**RESPONSE TO REQUEST FOR FURTHER INFORMATION  
PROPOSED REDEVELOPMENT OF BRISBANE WATER LEGACY SENIORS VILLAGE  
51-57 & 59 MASONS PARADE, POINT FREDERICK NSW**

### Brisbane Water Legacy - Responses to DPIE Request for Additional Information

### **IDG Architects Response to Referrals and Submissions**

DA-3101 B

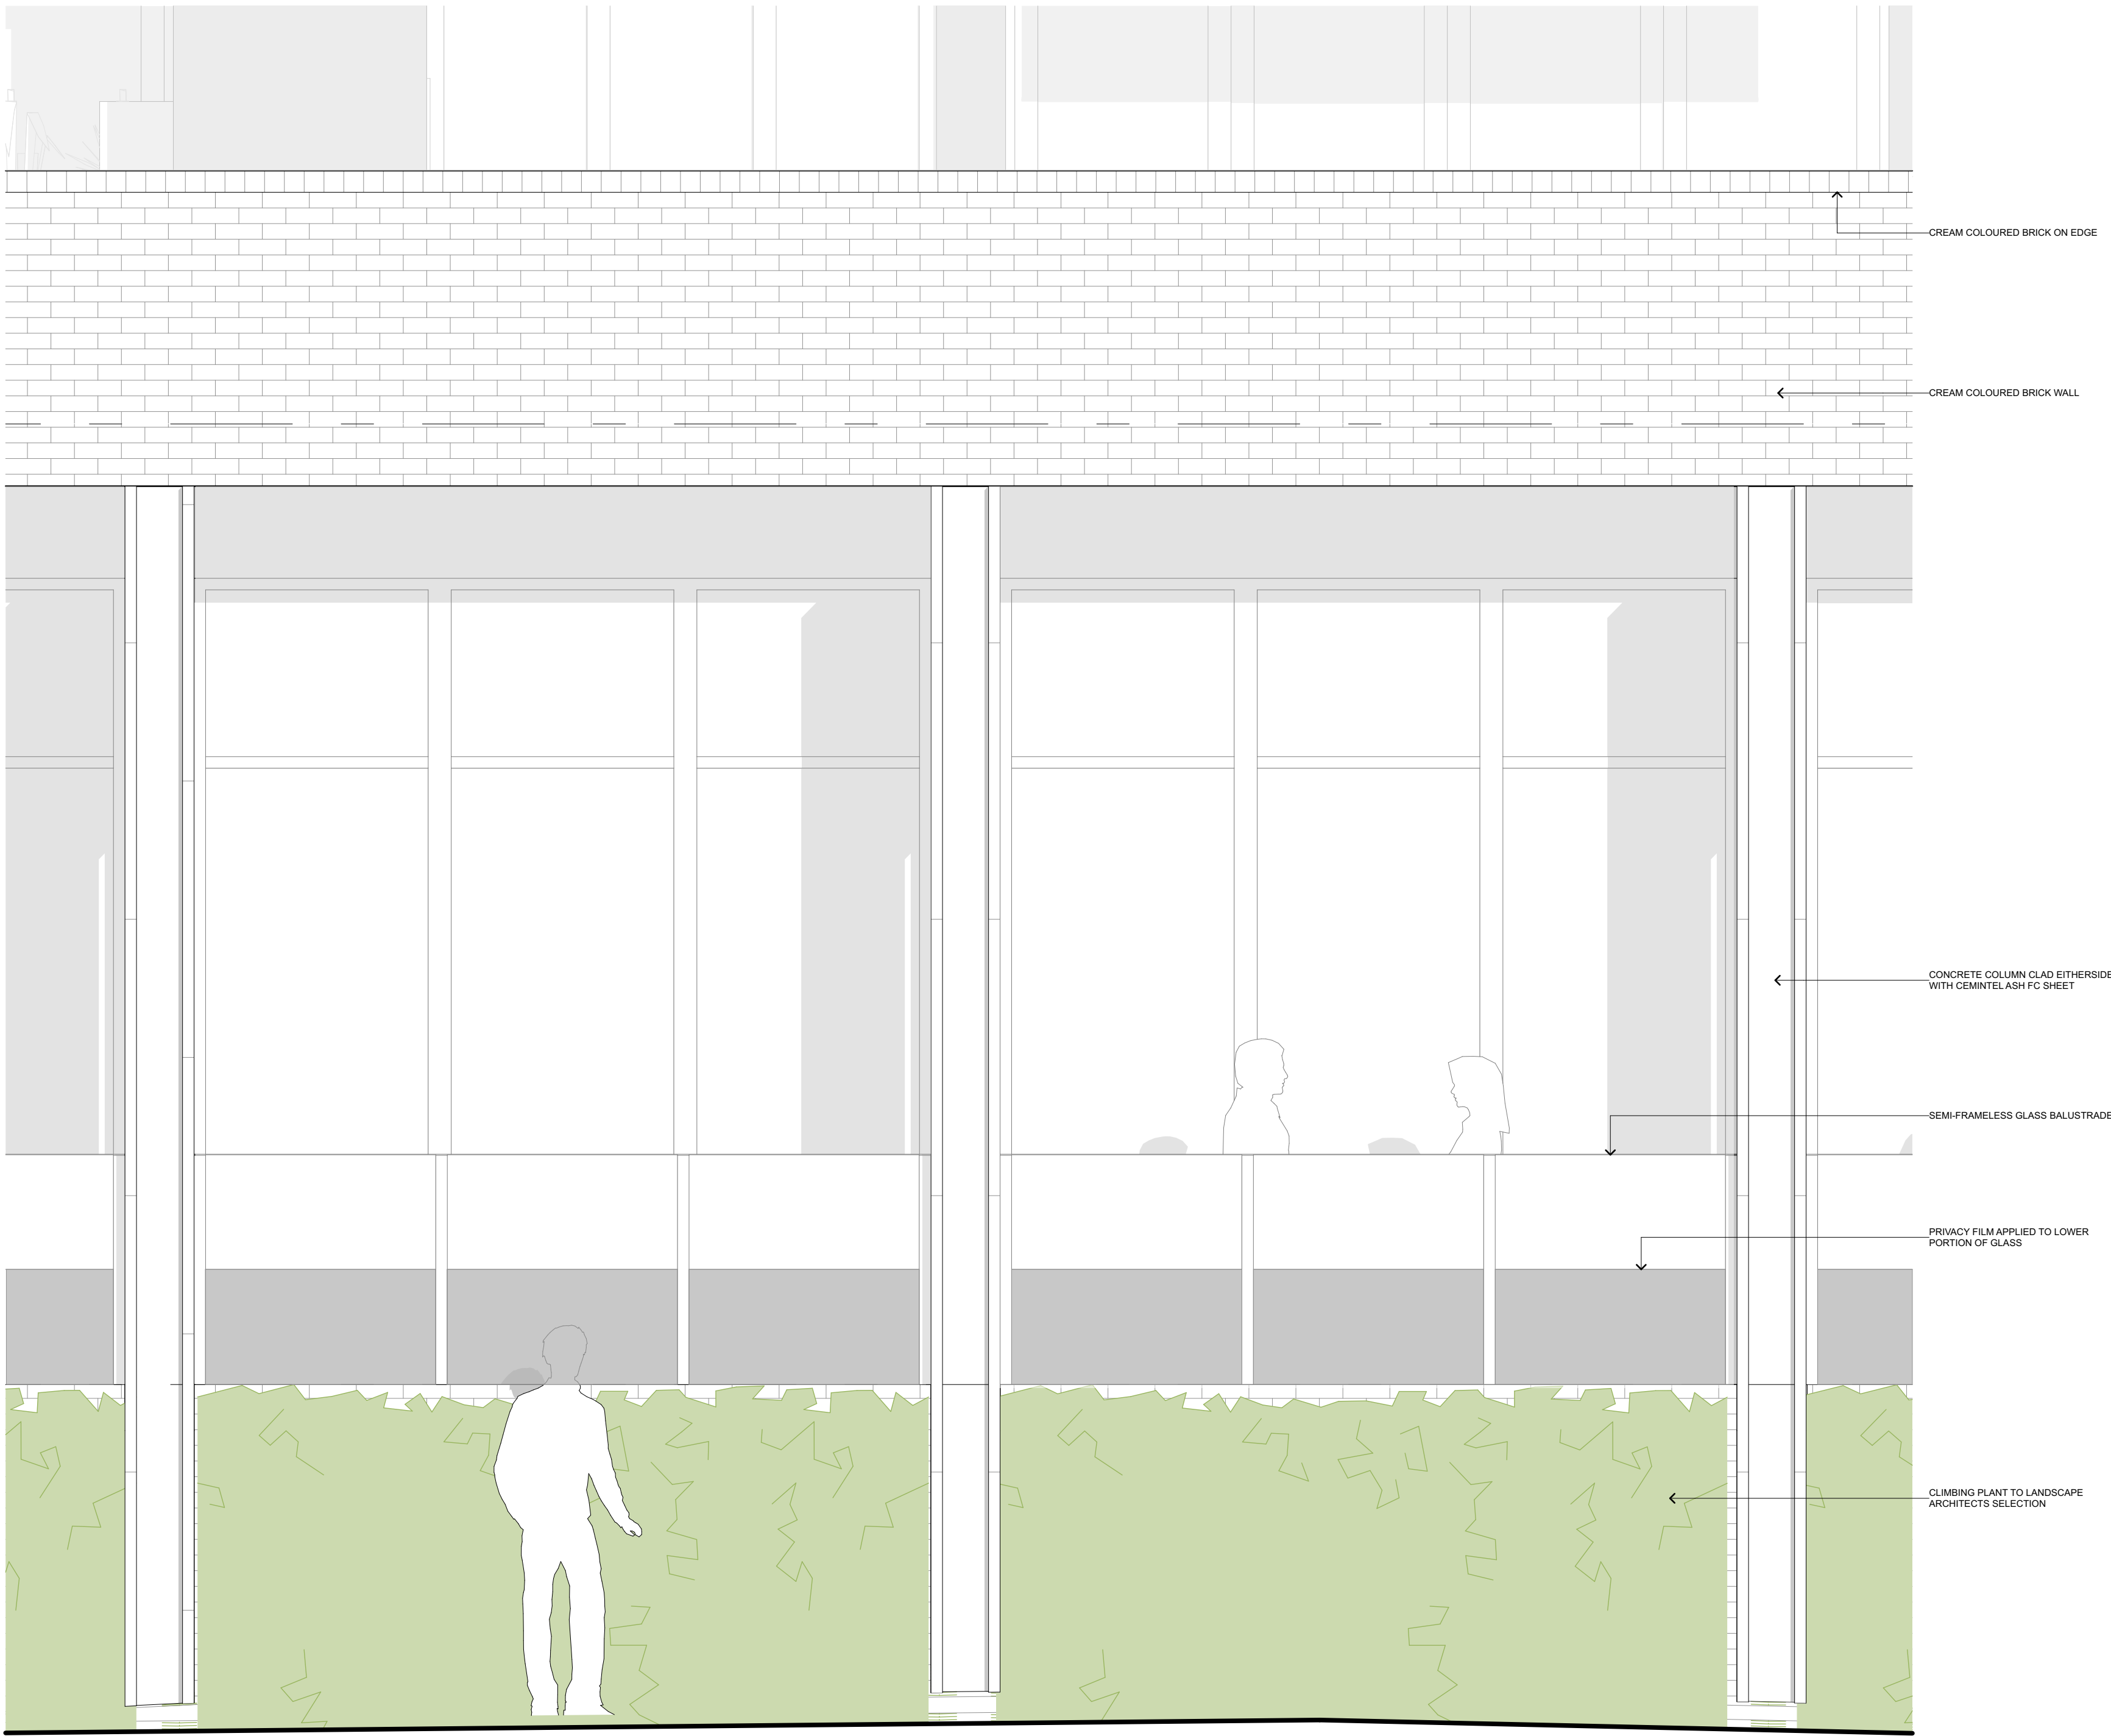
Item	Requested Information	Applicant's Response
	<b>20<sup>th</sup> December 2021 - Regional Assessments</b>	
1	A sun shading resident lounge area is required. Design solutions used in the existing design may be suitable to be used at this location	Refer to drawing DA-3101 Detailed Section a 'hekahood' 900mm wide is proposed - <b>Attachment B</b>
2	Submit detailed sections of the proposed facades to satisfy the State Environmental Planning Policy No 65 – Design Quality of Residential Apartment Development submission requirements under Schedule 2 Forms of the Environmental Planning and Assessment Regulation 2000.	Refer to drawing DA3100, DA-3101 and DA3102 Detailed Sections - <b>Attachment C</b>
3	Submit additional drawings, including elevations, for the maintenance and garbage storage building.	Refer to drawing DA 9400 Maintenance shed - <b>Attachment D</b>
	<b>27<sup>th</sup> January 2022 - Transport for NSW</b>

### **Sun Shading Resident Lounge**
